APPLICATION NO.	FILING DATE	FIRST NAMED INVENTOR	ATTORNEY DOCKET NO.	CONFIRMATION NO.
09/806,738	05/29/2001	Pieter Hendrik Albert Venemans	01100/LH	5982

Office Action Summary

DETAILED ACTION

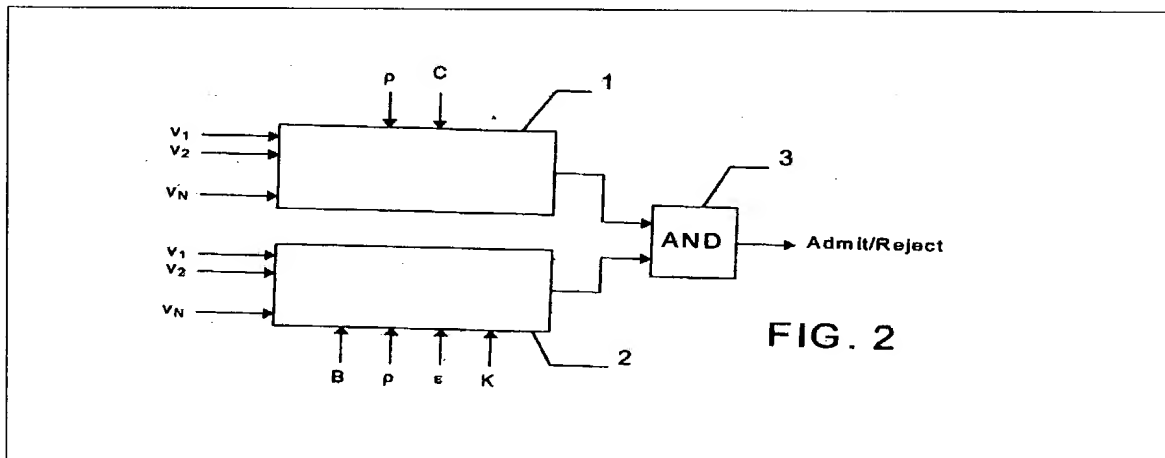
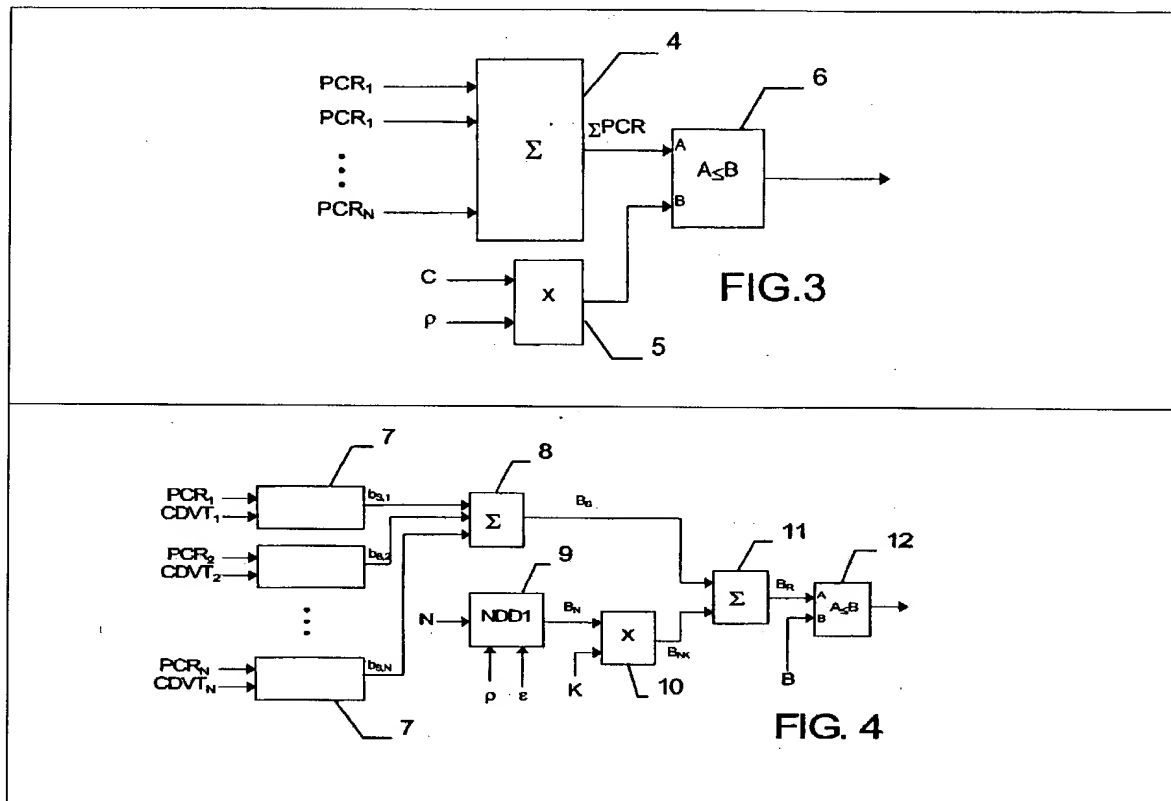
However, None of the prior art of record taken singularly or in combination taught or suggested a CAC device comprising to sub-devices (See Figure 2) each generating a positive or negative result and granting/admitting a connection request to the ATM switch only when both sub-devices issue a positive signal, the first sub-device device comprising two arithmetic units and a second sub-device comprising multiple arithmetic units each calculating and comparing specific values of the parameters related in determining admittance of a connection request to the ATM switch where the first device comprising two arithmetic units, arithmetic units one calculating sum of the nominal traffic parameters Peak Cell Rate (ΣPCR) of each ATM connections and second arithmetic unit comparing the computed sum (ΣPCR) with a value $\rho \times C$, where C is a capacity at an output port and ρ is a constant ($0 < \rho < 1$) corresponding to a desired maximum load (See Figure 3) a second sub-device comprising multiple arithmetic units (arithmetic units 3-7) and a comparison device (reference # 12 in Figure 4), where the third arithmetic unit (reference # 7 in Figure 4) calculates "a buffer capacity $b_{s,i}$, the value of $b_{s,i}$ being equal to zero if the product of the nominal Peak Cell Rate (PCR_i) and Cell Delay Variation Tolerance ($CDVT_i$) of the related connection is less than or equal to a constant K , and the value of $b_{s,i}$ being equal to said product minus the value of K if the product is greater than K ", a forth arithmetic unit (reference # 8 in Figure 4) computing the sum of the calculated values $b_{s,i}$ for all ATM connections at a related output port, a fifth arithmetic unit (reference # 9 in Figure 4) calculating a buffer capacity B_N , "such that upon multiplexing of N independent, identical and ideal ($CDVT = 0$) traffic streams, using a single buffer with a buffer capacity of B_N , and assuming a

maximum link load having a value of ρ , the average probability of cell loss as a result of buffer overflow will not exceed a given value of ϵ ," a sixth arithmetic unit (reference # 10 in Figure 4) which calculates a product (B_{NK}) of the value of B_N and the constant value K ; a seventh arithmetic unit (reference # 11 in Figure 4) which determines the sum (B_R) of the calculated values for B_S and B_{NK} ; and a comparison device (reference # 12 in Figure 4) which compares the calculated sum B_R with the given capacity B of the output buffer, a positive admission signal being emitted if the value of B_R is less than or equal to B , and a negative admission signal being emitted if the value of B_R is greater than B . The claimed invention is supported by the specification of the application (See Figures 2-4 below and Page 6, Line17 through Page 9, Line17).
